# Proposed Solar Power Station at Birchall Green Farm, Sinton Green

## Landscape and Visual Statement of Case

# Grimley Parish Council

October 2023

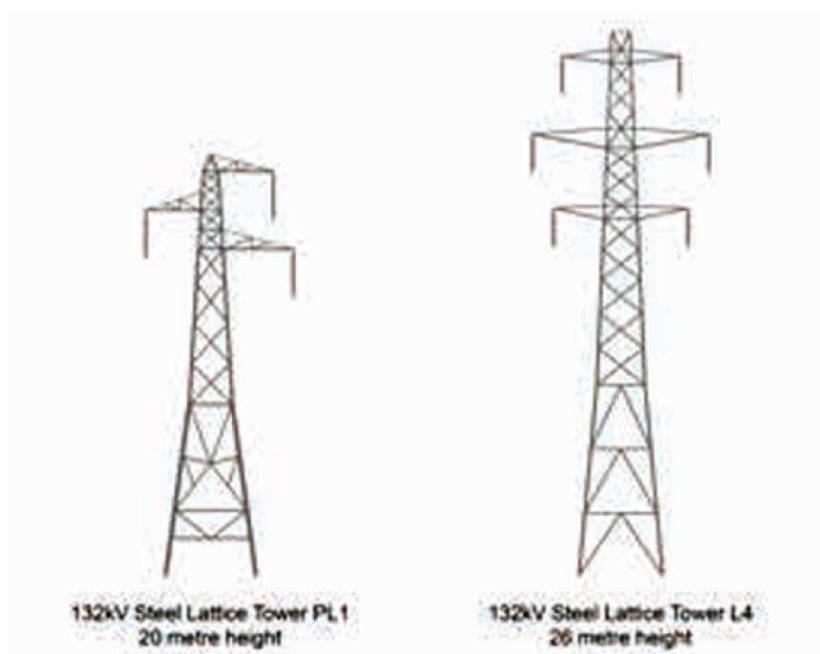
*'As a retired Overhead Line Engineer, I am concerned that no details about the connection to the existing WPD 132KV distribution network is included in the Planning Application for the Birchall Green Solar Farm.*

*'The SPD drawing P001.304.03 is the only drawing that contains any information about the connection and **the connection cannot be achieved as shown in this drawing.***

*'**The existing 132KV line consists of single circuit PL1 towers which are of 1932 vintage and the drawing shows a much bigger L4M modern tower.***

*'For information I have added a file to the comments to show the comparative size of an PL1 and L4M tower. The tower shown on the left is a standard height PL1 tower and the tower on the right is a standard height L4M tower.*

*'For the above reasons I feel that **the Planning Authority cannot contemplate the scheme without considering the visual impact that the DNO connection will have on the landscape** in this very sensitive area close to Monkwood.'*
